### NEEDHAM PLANNING BOARD

### Tuesday November 16, 2021 7:00 p.m.

7:20 p.m. Amendment to Major Project Site Plan Special Permit No. 2009-06: Town of Needham, 1471

8:30 p.m. Major Project Site Plan: Needham Enterprises, LLC, 105 Chestnut Street, Suite 28, Needham,

# PLAN REFERENCE:

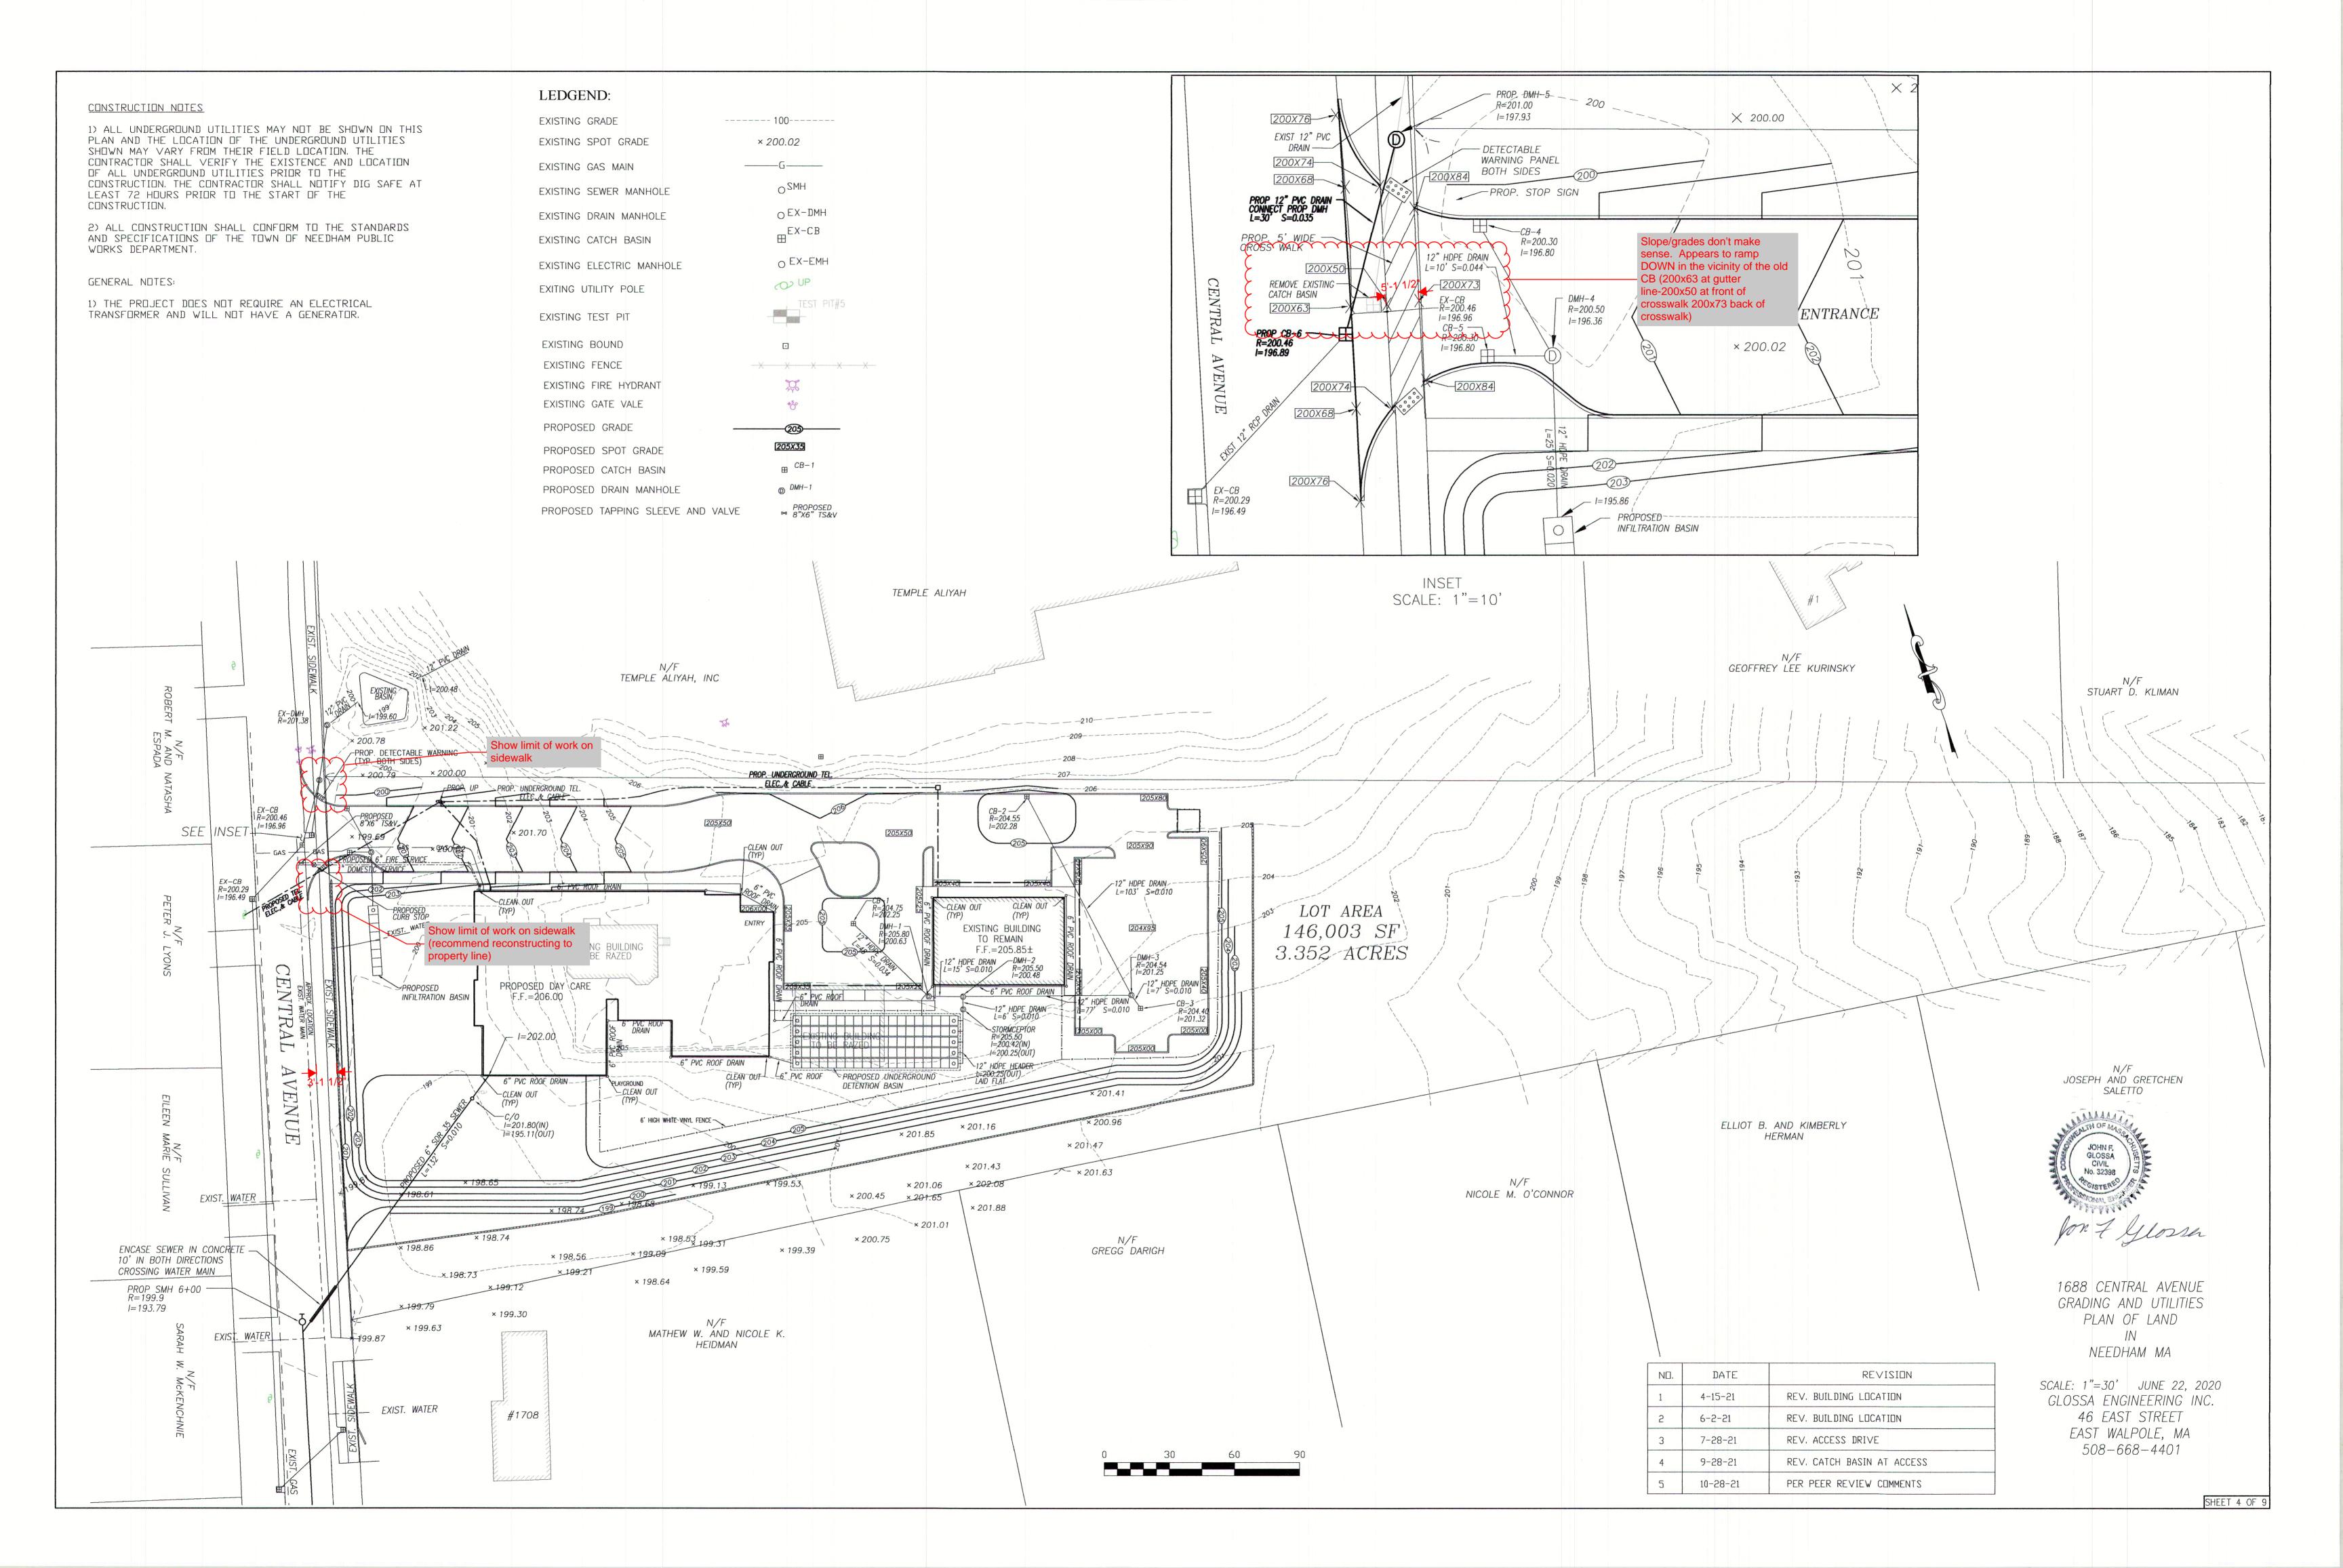
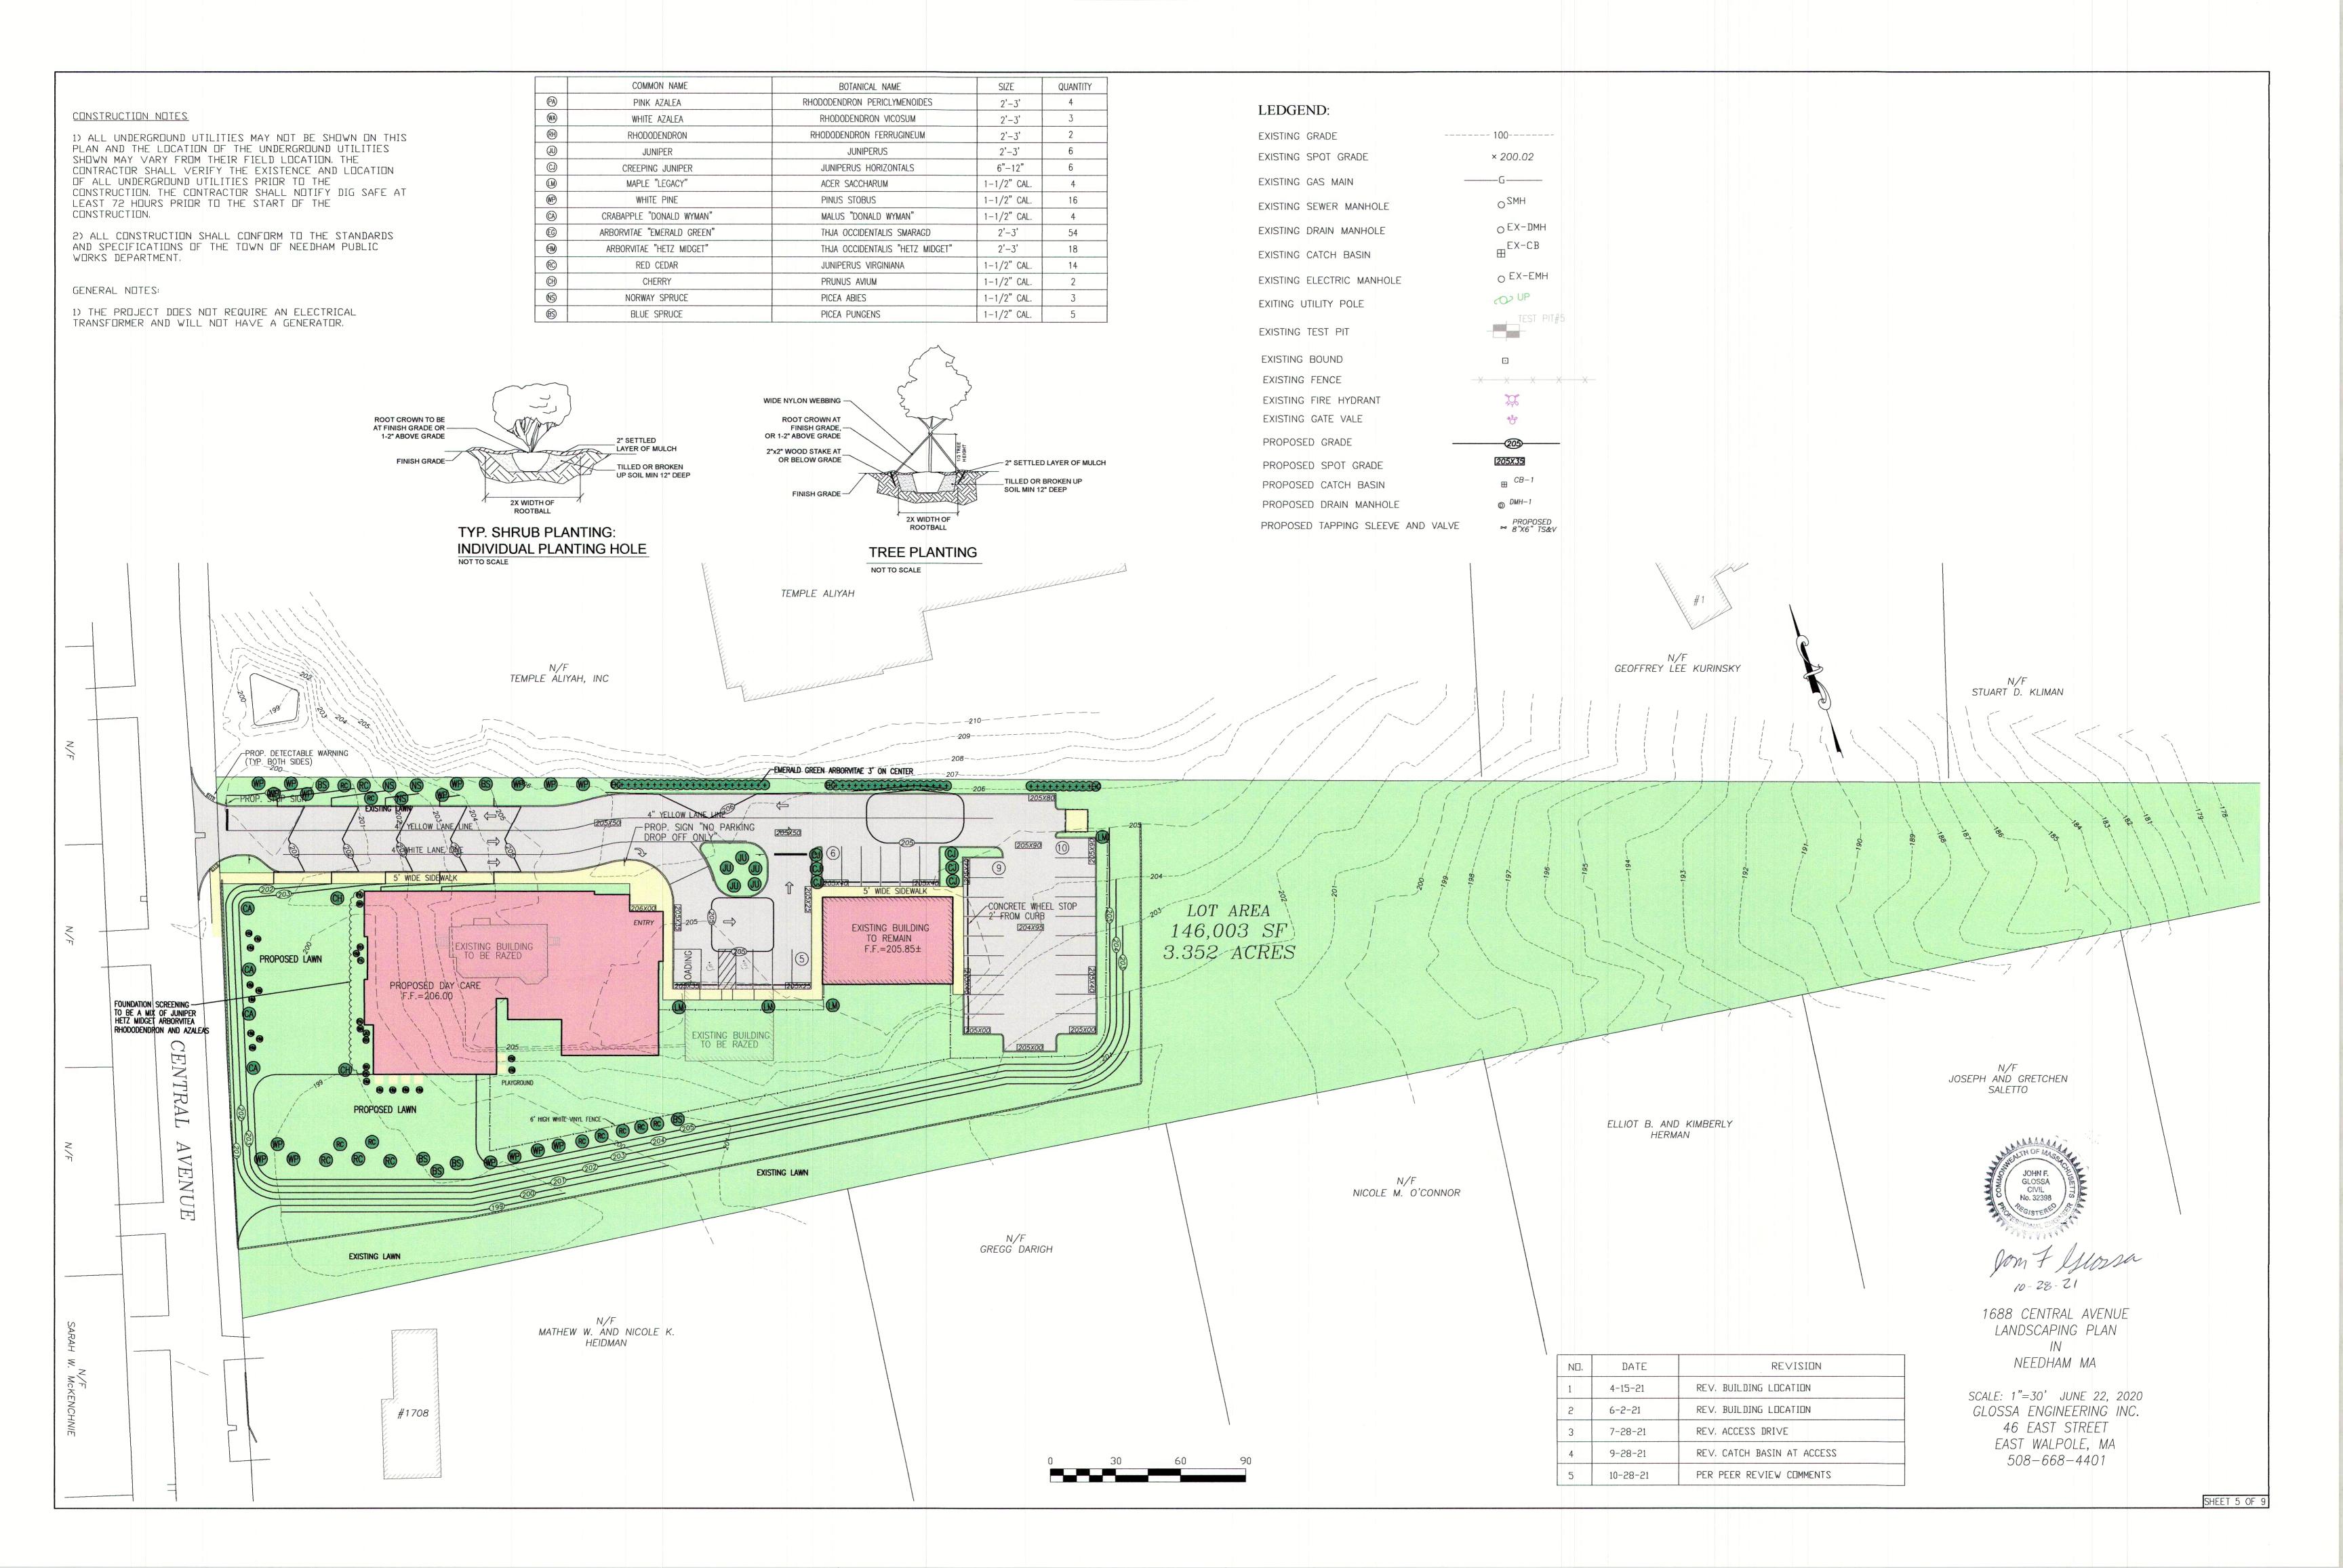
- a) Sheet 4 Proposed grades of the centerline of the driveway apron do not make sense. It appears to slope DOWN from the edge of road to the front of crosswalk by more than 2% and then slope up to the back of the crosswalk by more than 4%

- b) <u>Sheet 4 The spot grades 200x68 and 200x74 indicate the apron slope of about 1% UP at the sidewalk openings and a 1.8%-2.0% slope across the sidewalk/crosswalk, the apron portion should be sloped greater than the crosswalk portion.</u>

- c) Provide grades on sidewalk approaching driveway. It is unclear if the sidewalk slopes to the driveway or is level with the crossing.
- d) Sheet 4 Limit of work on the sidewalks should be indicated (also relates to Comment 2)

- e) Sheet 6 Detail should be provided for the proposed driveway apron.
- Sheet 8 & 9 Proposed CBs should be labeled and Existing CB to be removed should be labeled

- g) Sheet 10 Either delete labels on CBs (not relevant for lighting) or correctly label the Existing CB to be Removed
